FRAME FIELDS

FIXES TO THE FIELDS AND MISCELLANEOUS ISSUES

doc: IEEE 802.11 94/171A

■■■■ *Time Stamp in Beacon*

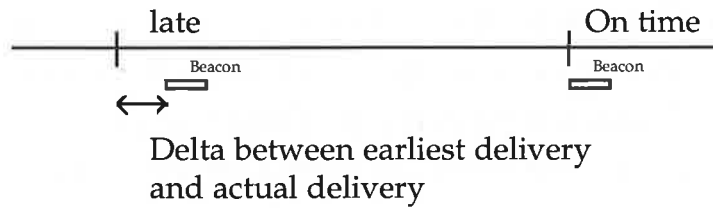
- The time stamp field is currently a 32 bit time of when the frame was transmitted.
 - » Doesn't do what is required
 - » Should be delta between when the frame should have gone out, and when it actually did go out.
 - » Allows a STA to really sync to the Beacon interval without memory.

- Change the Time Stamp field to be 16 bits of delta time in microseconds. Do this by using the relevant text in 94/171.
